## **DPO Case File for DPO-2005-002**

The following pdf represents a collection of documents associated with the submittal and disposition of a differing professional opinion (DPO) from an NRC employee involving Red Oil events at proposed MFFF.

DIFFERING PROFESSIONAL OPINION

**DIFFERING PROFESSIONAL OPINION ON**  
**RED OIL EVENTS AT THE**  
**PROPOSED MIXED OXIDE (MOX) FUEL FABRICATION FACILITY**  
**DOCKET NUMBER: 070-03098**

Figure A: Comparison of the Applicant's Red Oil Safety Strategies with DOE/DNFSB (formerly Open Item CS-01) Recommendations

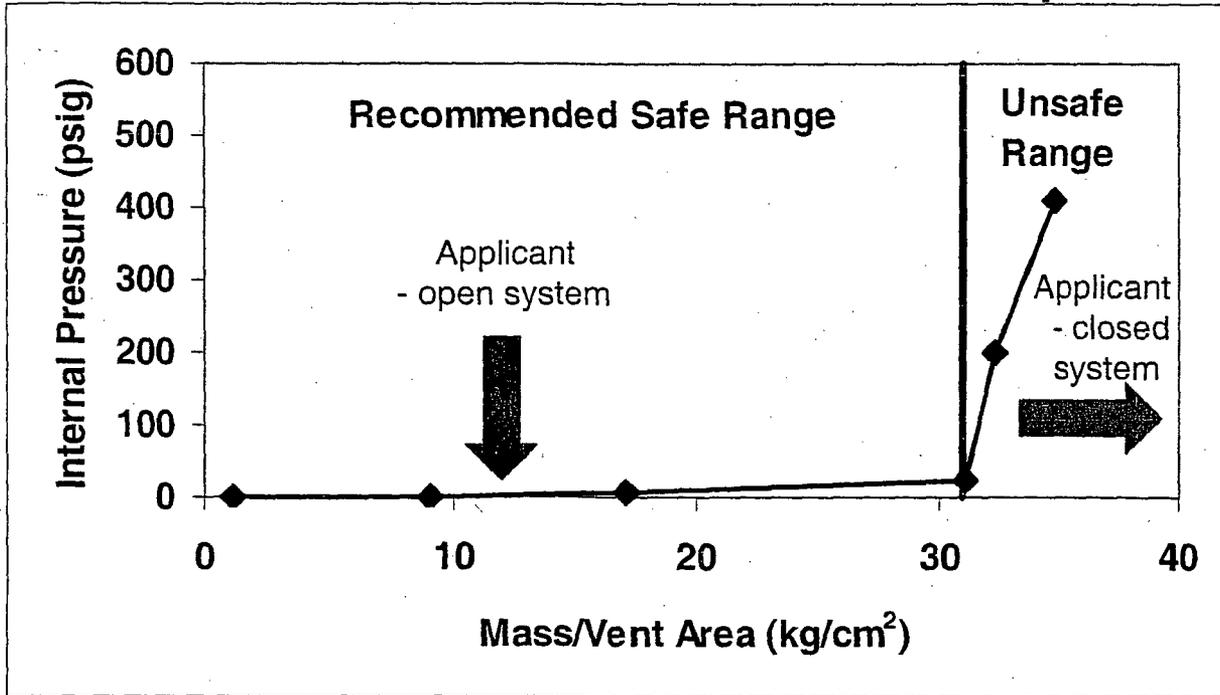
1. Contradictions with DOE/DNFSB RAGAGEP are not explained. In particular, the RAGAGEP shows the applicant's proposal for closed systems being entirely in the unsafe regime (Figure 2).

**Figure 1: Example of Facility Damage from a Red Oil Event - Tomsk, 1993.**

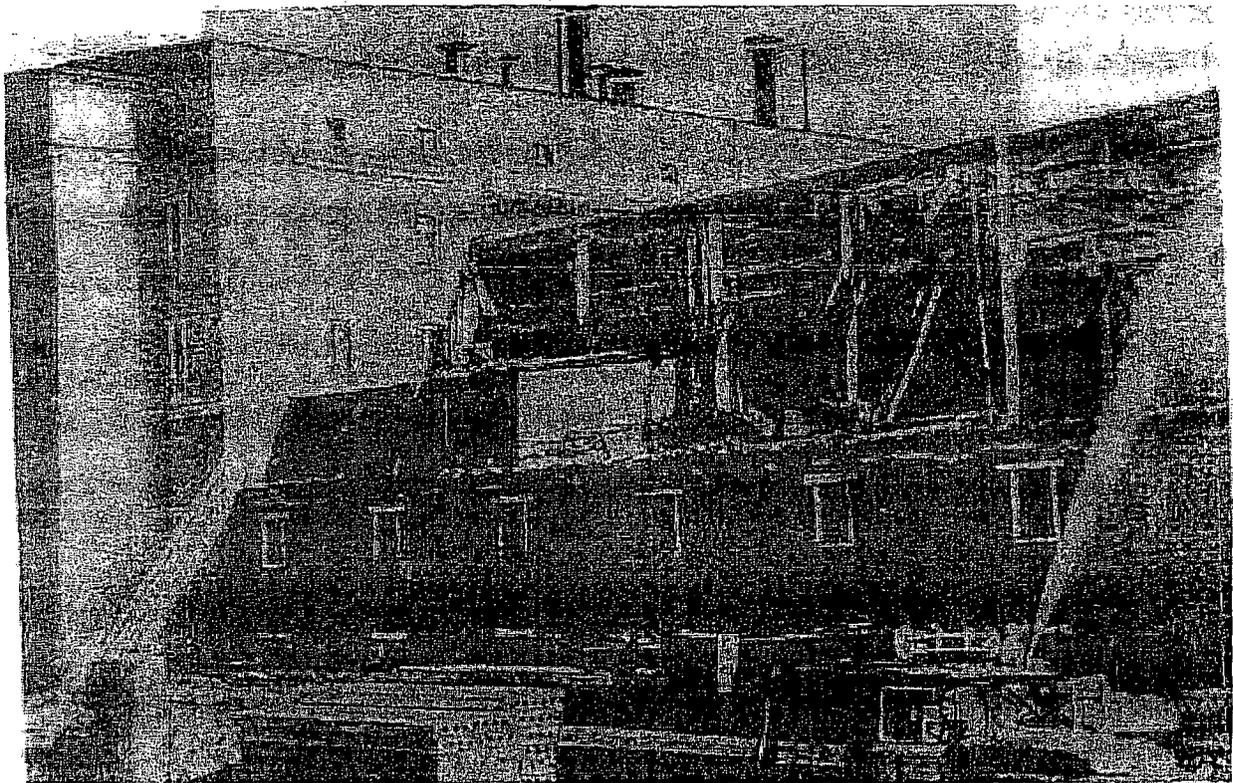
A photograph of the damage from the red oil event at Tomsk was removed from the DSER during editing. It is included as Figure 1, on the next page. Note that the event initiated in a shielded cell underneath the building, with relatively small quantities of materials reacting. Comparable quantities of organic materials could be present at the proposed MOX facility. A separate appendix on red oil events was also omitted from the DSER.

Figure 2: Comparison of the Applicant's Red Oil Safety Strategies with DOE/DNFSB (formerly Open Item CS-01) Recommendations

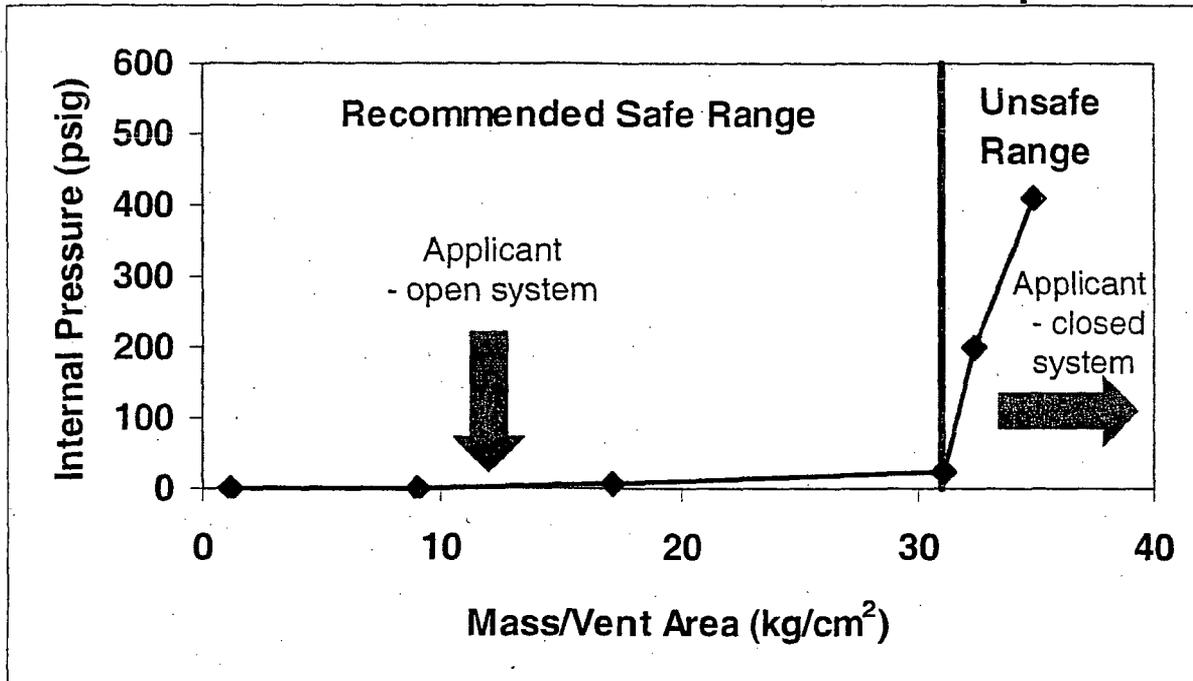
- **Pressure/Venting:** DOE/DNFSB use a pressure/vent relationship (Figure 2) that is well within the safe range identified from experimental testing. The applicant's approach for open systems is also well within the safe range. In contrast, the applicant's approach for closed systems (i.e., evaporative cooling) far exceeds the safe limit and is well into the unsafe range. Common mode failure is likely - reaction products from the red oil reactions cannot escape and provide evaporative cooling, resulting in choked flow, which increases temperature, resulting in suppressed evaporation, which increases temperature, resulting in increased red oil reaction rates etc. - ultimately, this leads to a runaway reaction and explosion. The loss of evaporative cooling effectiveness above 120 C is noted in articles cited in the staff's DSER and RDSER.

1. Contradictions with DOE/DNFSB RAGAGEP are not explained. In particular, the RAGAGEP shows the applicant's proposal for closed systems being entirely in the unsafe regime (Figure 2).
2. There is inadequate margin in the design basis temperature.
3. The venting is insufficient to avoid choked flow and pressurization, which has the ability to rapidly raise the temperature even with the applicant's proposed strategy functioning.

Figure A: Comparison of the Applicant's Red Oil Safety Strategies with DOE/DNFSB (formerly Open Item CS-01) Recommendations

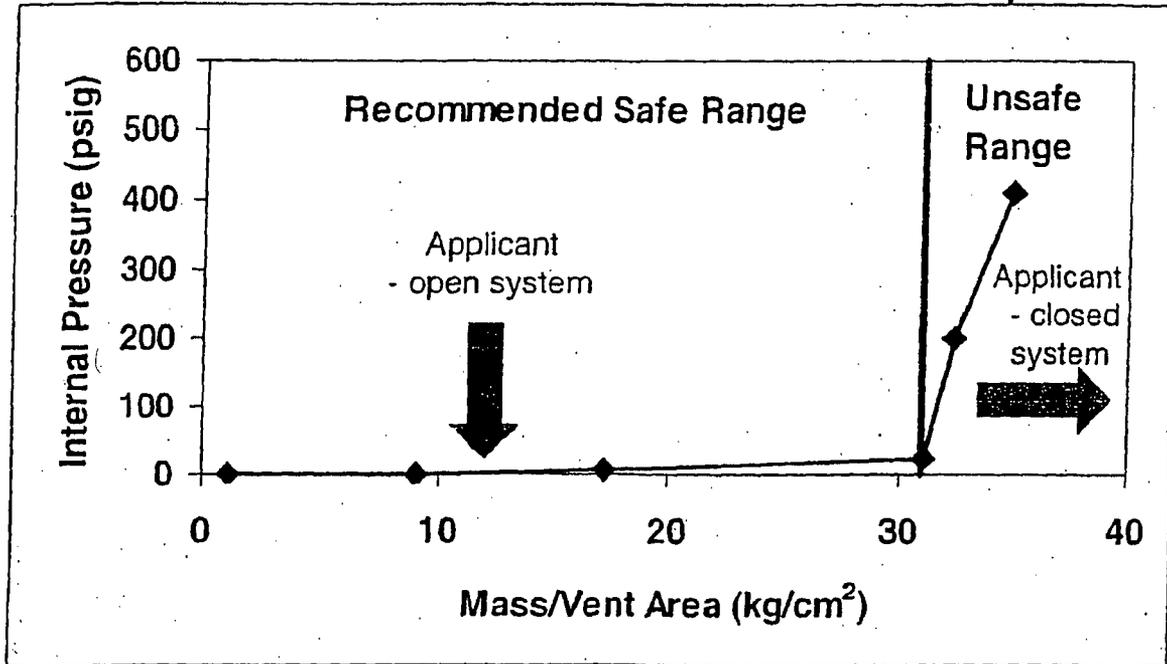
1. Contradictions with DOE/DNFSB RAGAGEP (Reasonable And Generally Accepted Good Engineering Practice) are not explained. In particular, the RAGAGEP shows the applicant's proposal for closed systems being entirely in the unsafe regime (Figure 2).
2. There is inadequate margin in the design basis temperature.
3. The venting is insufficient to avoid choked flow and pressurization, which has the ability to rapidly raise the temperature even with the applicant's proposed strategy functioning.

Figure 2: Comparison of the Applicant's Red Oil Safety Strategies with DOE/DNFSB (formerly Open Item CS-01) Recommendations

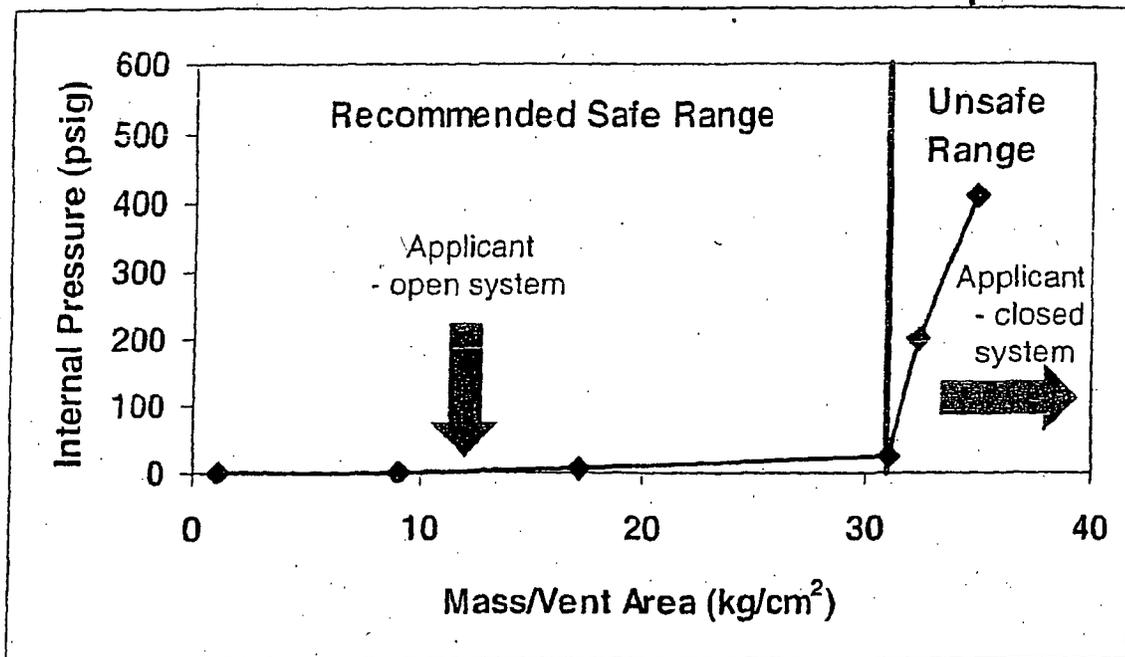
**Pressure/Venting:** DOE/DNFSB use a pressure/vent relationship (Figure 2) that is well within the safe range identified from experimental testing. The applicant's approach for open systems is also well within the safe range. In contrast, the applicant's approach for closed systems (i.e., evaporative cooling) far exceeds the safe limit and is well into the unsafe range. Common mode failure is likely - reaction products from the red oil reactions cannot escape and provide evaporative cooling, resulting in choked flow, which increases temperature, resulting in suppressed evaporation, which increases temperature, resulting in increased red oil reaction rates etc. - ultimately, this leads to a runaway reaction and explosion. The loss of evaporative cooling effectiveness above 120 C is noted in articles cited in the staff's DSER and RDSER.

1. Contradictions with DOE/DNFSB RAGAGEP are not explained. In particular, the RAGAGEP shows the applicant's proposal for closed systems being entirely in the unsafe regime (Figure 2).
2. There is inadequate margin in the design basis temperature.
3. The venting is insufficient to avoid choked flow and pressurization, which has the ability to rapidly raise the temperature even with the applicant's proposed strategy functioning.

Figure A: Comparison of the Applicant's Red Oil Safety Strategies with DOE/DNFSB (formerly Open Item CS-01) Recommendations

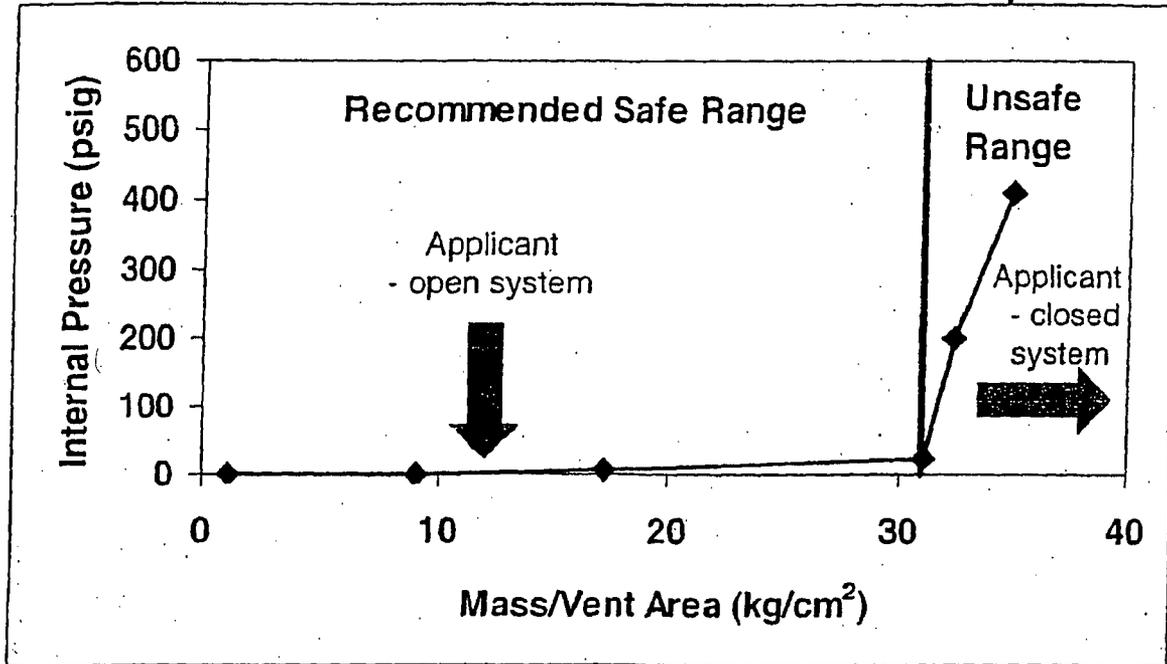
1. Contradictions with DOE/DNFSB RAGAGEP (Reasonable And Generally Accepted Good Engineering Practice) are not explained. In particular, the RAGAGEP shows the applicant's proposal for closed systems being entirely in the unsafe regime (Figure 2).
2. There is inadequate margin in the design basis temperature.
3. The venting is insufficient to avoid choked flow and pressurization, which has the ability to rapidly raise the temperature even with the applicant's proposed strategy functioning.

Figure 2: Comparison of the Applicant's Red Oil Safety Strategies with DOE/DNFSB (formerly Open Item CS-01) Recommendations

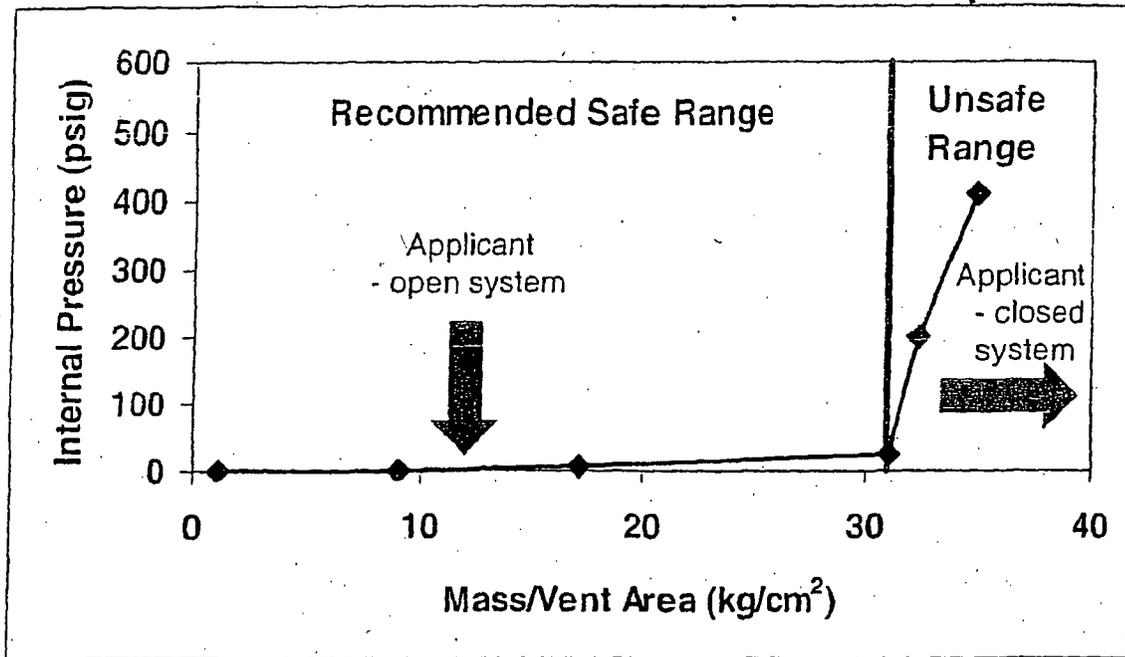
**Pressure/Venting:** DOE/DNFSB use a pressure/vent relationship (Figure 2) that is well within the safe range identified from experimental testing. The applicant's approach for open systems is also well within the safe range. In contrast, the applicant's approach for closed systems (i.e., evaporative cooling) far exceeds the safe limit and is well into the unsafe range. Common mode failure is likely - reaction products from the red oil reactions cannot escape and provide evaporative cooling, resulting in choked flow, which increases temperature, resulting in suppressed evaporation, which increases temperature, resulting in increased red oil reaction rates etc. - ultimately, this leads to a runaway reaction and explosion. The loss of evaporative cooling effectiveness above 120 C is noted in articles cited in the staff's DSER and RDSER.

1. Contradictions with DOE/DNFSB RAGAGEP are not explained. In particular, the RAGAGEP shows the applicant's proposal for closed systems being entirely in the unsafe regime (Figure 2).
2. There is inadequate margin in the design basis temperature.
3. The venting is insufficient to avoid choked flow and pressurization, which has the ability to rapidly raise the temperature even with the applicant's proposed strategy functioning.
